Delegated Report		Analysis sheet		Expiry Date: 08/07/2024	
		N/A		Consultation Expiry Date: 10/06/2024	
Officer			Application Number(s)		
Ewan Campbell			2024/1122/P		
Application Address			Drawing Numbers		
Frognal Garages on land west of Ashley Court Frognal Lane London NW3 7DX			Please refer to draft decision notice		
PO 3/4	Area Team Signature	C&UD	Authorised Officer Signature		
Proposal(s)					
Demolition of existing garages and the erection of 2 x dwellinghouses (Class C3) with excavation of basement, associated amenity space, four new garage spaces, front and rear landscaping and associated works.					
Recommendation(s):		Refuse Planning Permission			
Application Type:		Full Planning Permission			
Conditions or Reasons for Refusal:		Refer to Draft Decision Notice			
Informatives:					
Consultations					
		No. of responses	37	No. of objections	26
Neighbour Consultation		<p>A site notice was put up on 17/05/2024 and expired on the 10/06/2024</p> <p>26 objections were received from neighbours including by Cllr Steve Adams. Concerns include:</p> <ul style="list-style-type: none"> - Excessive bulk and massing - Excessive height in this location - Overdevelopment - Loss of privacy

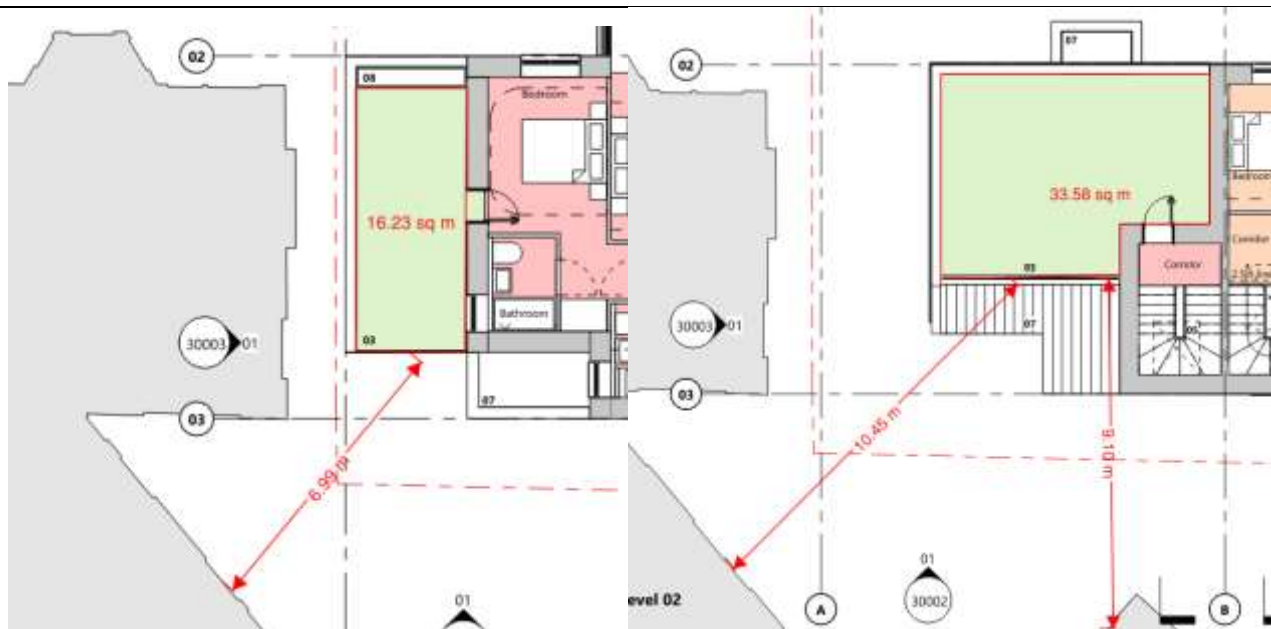
- 3.1.19. An Architects note was also submitted attempting to demonstrate that the pre-application advice by the Council would not work. The figure below shoes that if the design split the uses then the basement rooms would fail daylight/sunlight

- 3.1.20. However, this actually shows the potential for this move; the basement could just be removed and then there would be two acceptable 2-bedroom units with amenity space. By doing this the design could be more rational and easily replicated across the site once/if the garages become available. If you overlay the floor plans on to where the garages are you then get four good quality units. See figure 2 below:
